Access Compliance Report

Public Rights-of-Way

Intersection ID: 17089	Main Street: BRIDLEPATH_LN	Cross Street: WALKER_RD	Location: NW
ADA ID: 441D20267FD2	Ramp Type: PerpDiag	Initial Pass/Fail: Pass	Overall Compliance: No
			Severity Score: 11.75

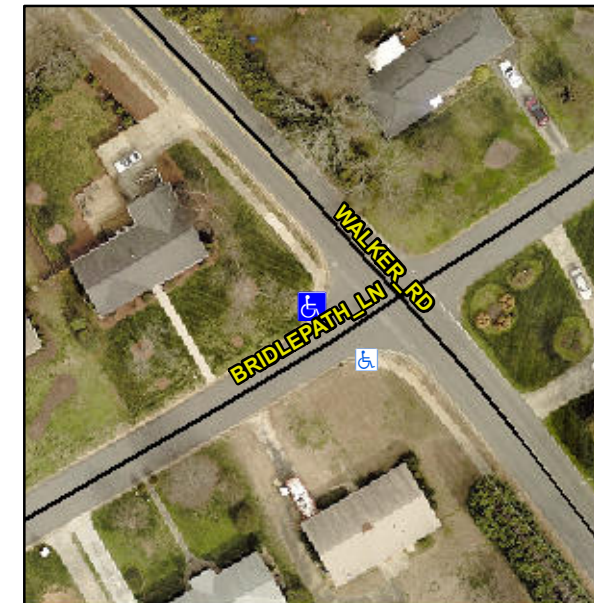
Not Found, R304.5.3, R304.2.1, R304.2.2-Perp, R304.3.2-Para, R305.2, R302.7.2

Compliance	Description	Data	Compliance	Description	Data
N/A	Ramp Length (in)	27.0	Yes	Ramp Slope (%)	6.2
Yes	Ramp Width (in)	48.0	No	Ramp XSlope (%)	2.2
N/A	Flare Type LT	Sloped	N/A	Flare Type RT	N/A
N/A	Flare Slope LT (%)	5.8	Yes	Flare Slope RT (%)	4.0
N/A	Flare Traversable LT?	Yes	N/A	Flare Traversable RT?	Yes
No	Landing Length (in)	34.0	Yes	DWS Provided?	Yes
No	Landing Width (in)	39.5	Yes	DWS Contrast?	Yes
No	Landing Slope (%)	2.2	Yes	DWS Length (in)	24.0
No	Landing X Slope (%)	2.3	Yes	DWS Full Width?	Yes
N/A	Landing Curb? (Y/N)	No	No	DWS Offset (in)	3.0
N/A	Shared Landing?	No			
Yes	Gutter Ponding?	No	Yes	Gutter Slope (%)	5.0
No	Gutter Lip Ht (in)	0.5	Yes	Gutter X Slope (%)	2.0
N/A	Painted X Walk1?	No	N/A	Painted X Walk2?	No
	X Walk 1 Direction	To SE		X Walk 2 Direction	To E
N/A	X Walk 1 Width (in)	N/A	N/A	X Walk 2 Width (in)	N/A
	X Walk 1 Slope (%)	6.6		X Walk 2 Slope (%)	0.3
	X Walk 1 X Slope (%)	2.3		X Walk 2 X Slope (%)	4.1

Remove & Replace Curb Ramp With Two New Directional Ramps or Equivalent.
